DCN No.
LAT-XR-774-01**DOCUMENT CHANGE NOTICE (DCN)**

ORIGINATOR:	Michael Amato	PHONE:	(301) 286-3914	DATE:	5/31/02
CHANGE TITLE: Combination of all updates from past six months plus changes to trigger width and delays				ORG.:	NASA GSFC
DOCUMENT NUMBER		TITLE		NEW REV.	
LAT-SS-00016		LAT ACD Subsystem Specification- Level III Specification		Draft 13-controlled release 2

GLAST LAT SUBSYSTEM SPECIFICATION	Document #	Date Effective
	LAT-SS-00016-D13	Draft 2/08/02
	Responsible Engineer(s) M. Amato, G. Shibley, B Hartman, D. Thompson	Supersedes None
	Subsystem/Office ACD Subsystem	
Document Title LAT ACD Subsystem Specification - Level III Specification

Figure 2-1 LAT Specification Tree

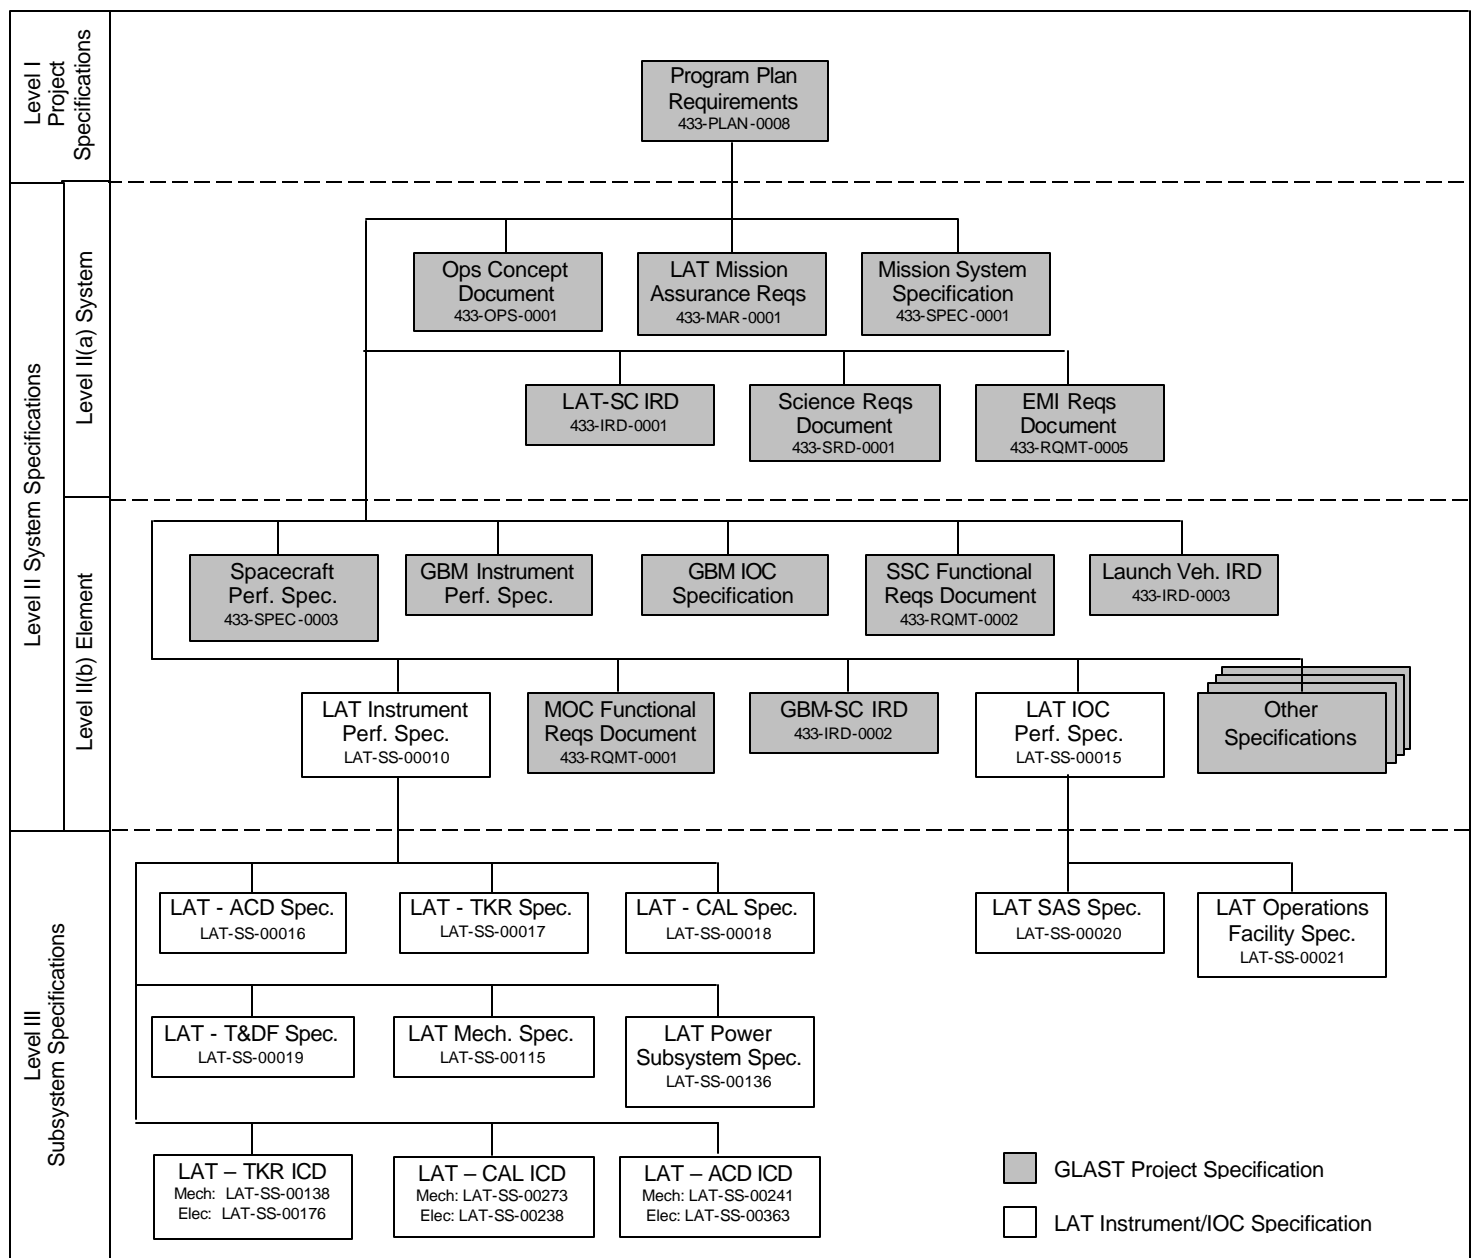
- * Updated Figure 2-1 LAT Specification Tree with latest one which first appeared in December release of LAT level IIb reqs/specs
- * Added ACD to acronyms, added ACD signature page
